Access Compliance Report

Public Rights-of-Way

(Curb Ramps)

Intersection ID: 45830	Main Street: EMMA_LYNN_CT	Cross Street: CHRISTENBURY_HILLS_LN	Location: NE
ADA ID: 54B801197B1E	Ramp Type: PerpDiag	Initial Pass/Fail: Fail	Overall Compliance: No
Severity Score: 31.25			
Codes/Mitigation Info/Possible Solution		Field Measurements/Component Compliance

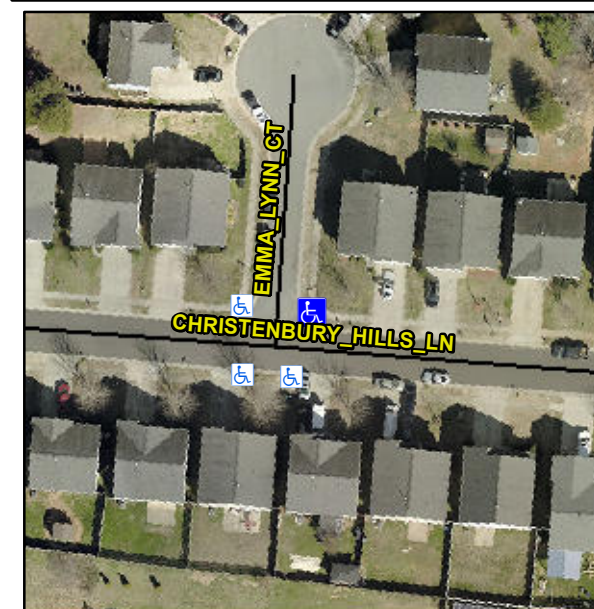
Not Found, R304.5.1, R304.2.2, R304.5.3

Compliance	Description	Data	Compliance	Description	Data
N/A	Ramp Length (in)	48.0	No	Ramp Slope (%)	8.7
No	Ramp Width (in)	35.5	No	Ramp XSlope (%)	4.4
N/A	Flare Type LT	N/A	N/A	Flare Type RT	N/A
N/A	Flare Slope LT (%)	N/A	N/A	Flare Slope RT (%)	N/A
N/A	Flare Traversable LT?	N/A	N/A	Flare Traversable RT?	N/A
N/A	Landing Length (in)	N/A	N/A	DWS Provided?	N/A
N/A	Landing Width (in)	N/A	N/A	DWS Contrast?	N/A
N/A	Landing Slope (%)	N/A	N/A	DWS Length (in)	N/A
N/A	Landing X Slope (%)	N/A	N/A	DWS Full Width?	N/A
N/A	Landing Curb? (Y/N)	N/A	N/A	DWS Offset (in)	N/A
N/A	Shared Landing?	N/A			
N/A	Gutter Ponding?	N/A	N/A	Gutter Slope (%)	N/A
N/A	Gutter Lip Ht (in)	N/A	N/A	Gutter X Slope (%)	N/A
N/A	Painted X Walk1?	No	N/A	Painted X Walk2?	No
	X Walk 1 Direction	To W		X Walk 2 Direction	To S
N/A	X Walk 1 Width (in)	N/A	N/A	X Walk 2 Width (in)	N/A
	X Walk 1 Slope (%)	3.2		X Walk 2 Slope (%)	2.5
	X Walk 1 X Slope (%)	1.7		X Walk 2 X Slope (%)	4.7

Remove & Replace Curb Ramp With Two New Directional Ramps or Equivalent.
